CITY OF ALBUQUERQUE

RE: Starbucks
8721 Washington St NE
Grading and Drainage Plan
Engineer's Stamp Date: 11/20/20
Hydrology File: C17D128

DRAINAGE AND TRANSPORTATION INFORMATION SHEET (REV 11-2018)

PROJECT TITLE STARBUCKS 8721 WASHINGTON ST. NE ALBUQUERQUE, NEW MEXICO 87113	DRAWN BY: JEFF WOOTEN
PROJECT MANAGER JEFF WOOTEN	JOB NO. 2020027
SHEET TITLE Grading Plan	DATE 11/20/2020
SCALE: AS NOTED	SHEET C1.1
	OF 3

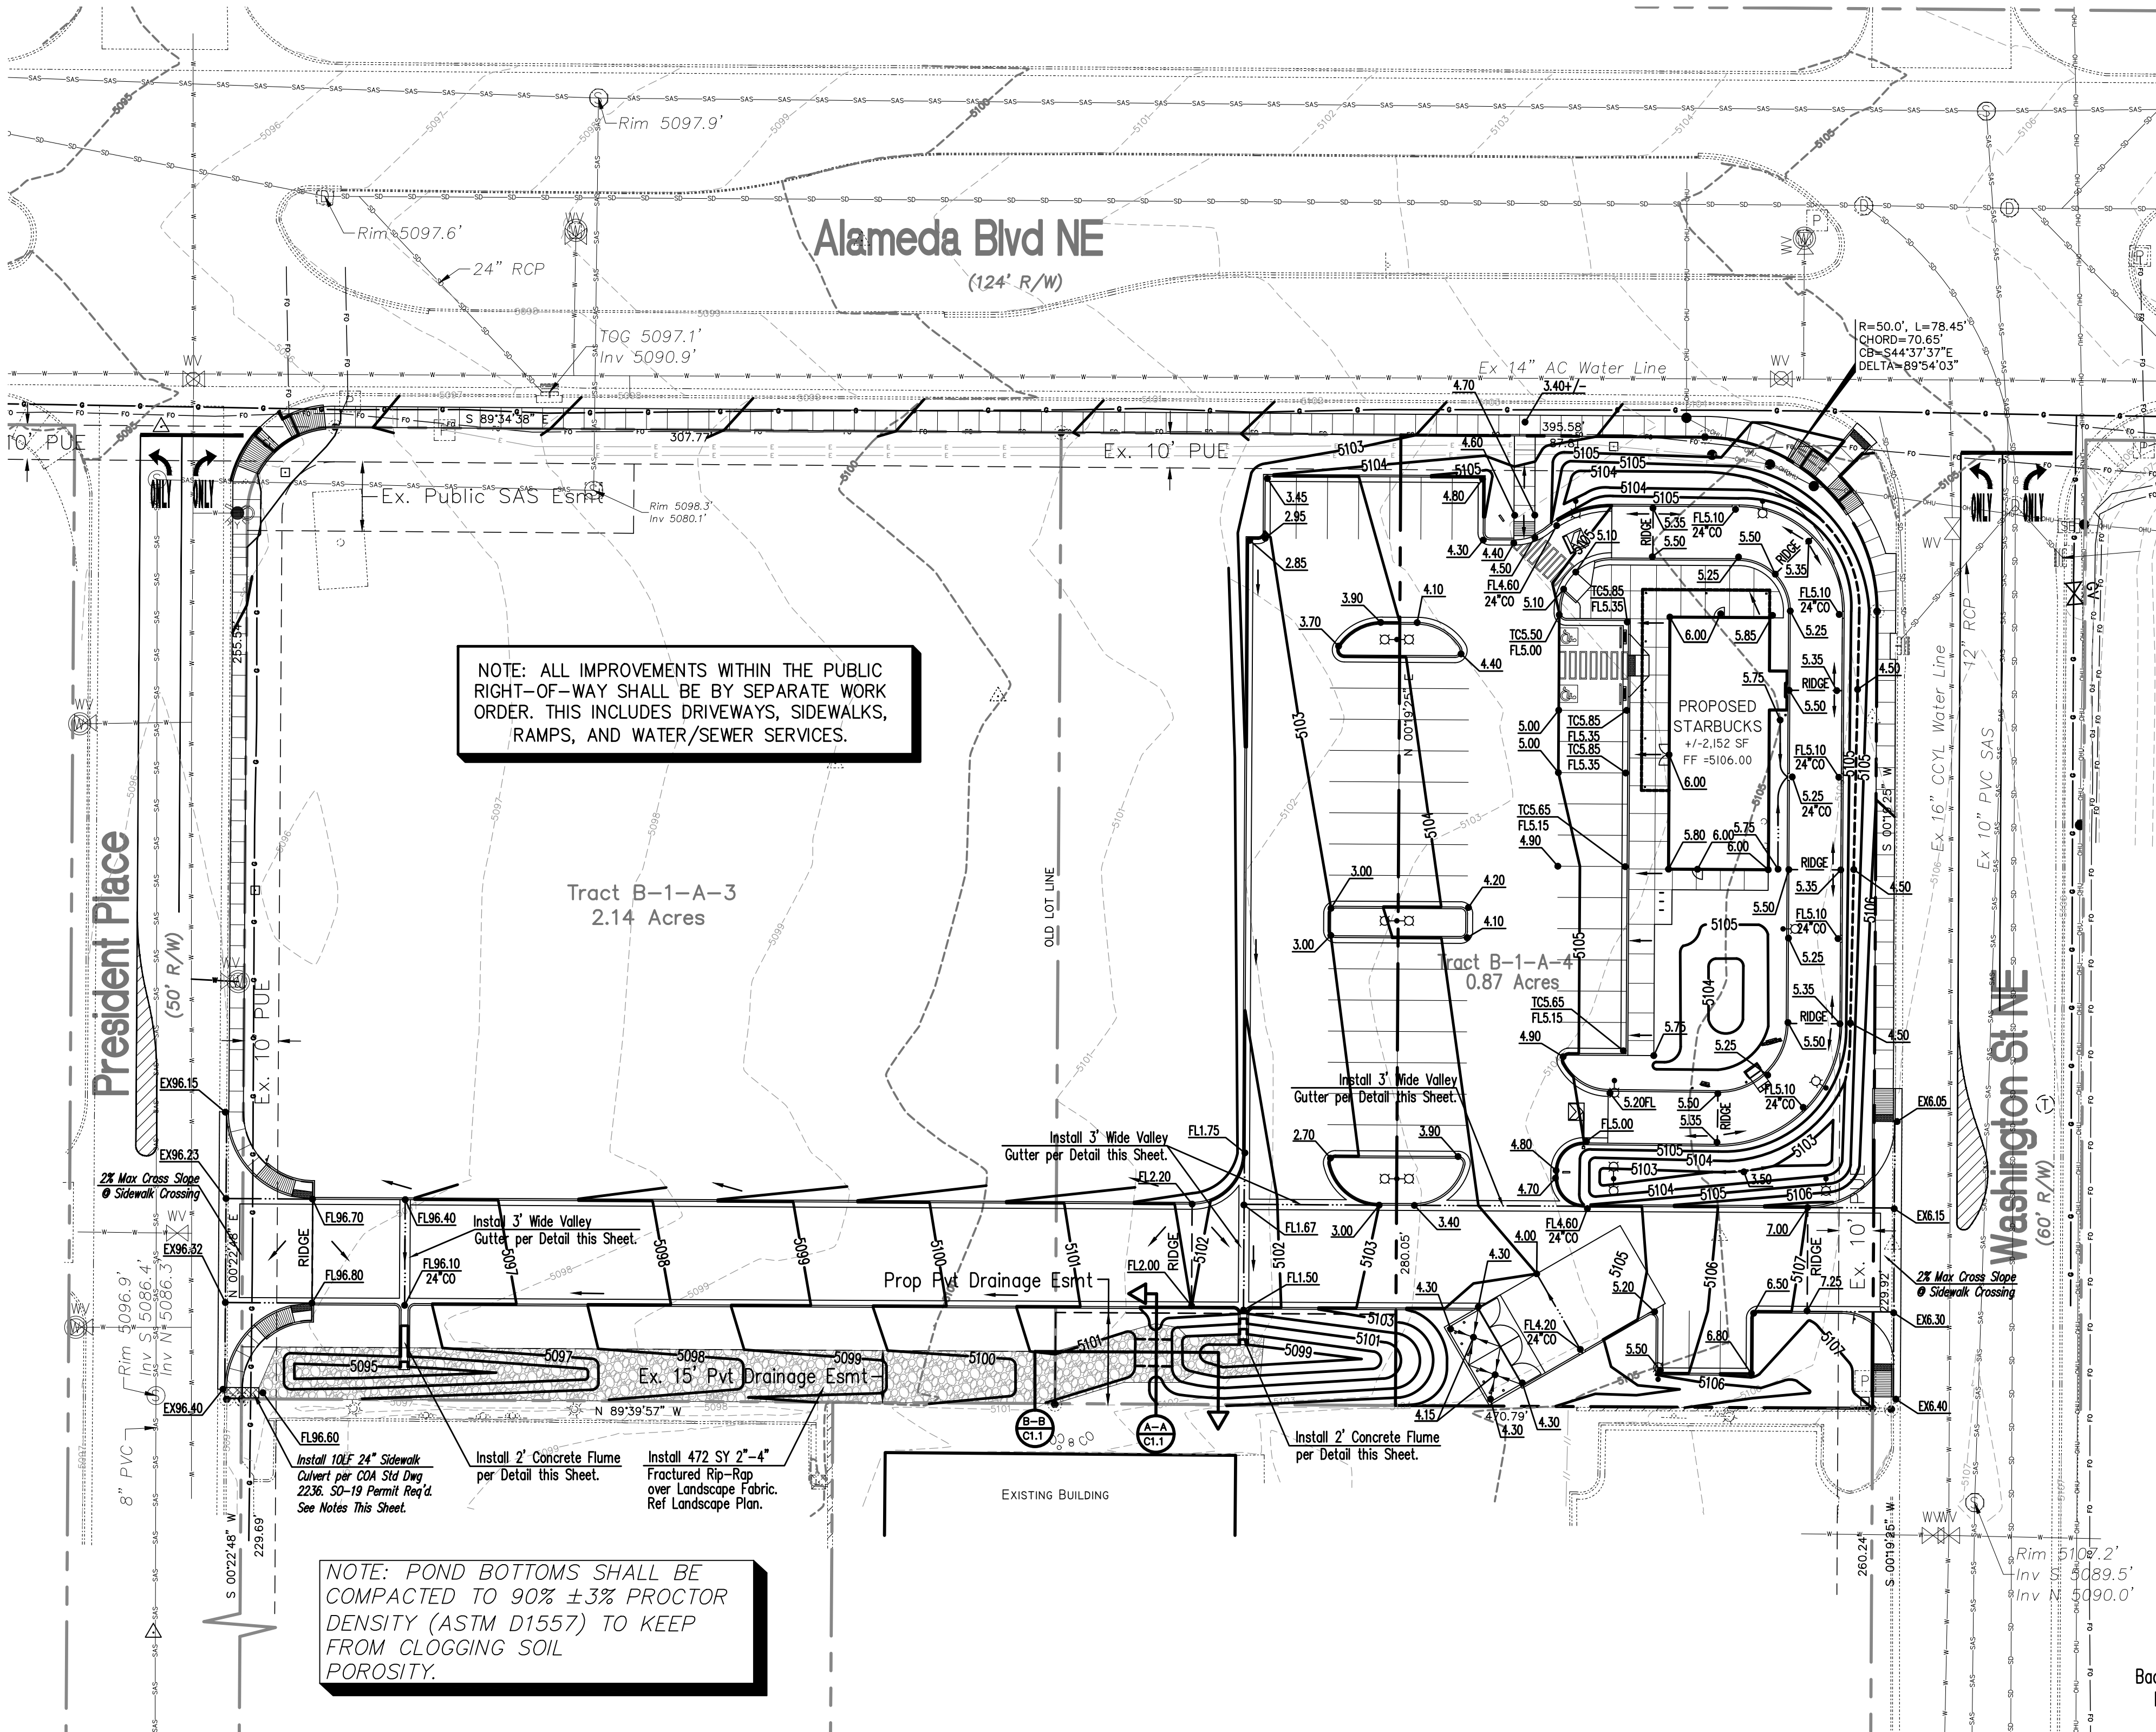
Based upon the information provided in your submittal received 11/20/2020, the Grading and Drainage Plan is approved for Building Permit.

Also, please provide the Drainage Covenant for the proposed stormwater quality ponds per Article 6-15(C) of the DPM prior to Permanent Release of Occupancy. There is a recording fee (\$25, payable to Bernalillo County). Please contact Charlotte LaBadie (clabadie@cabq.gov, 924-3996). Due to COVID-19, please follow the instructions:
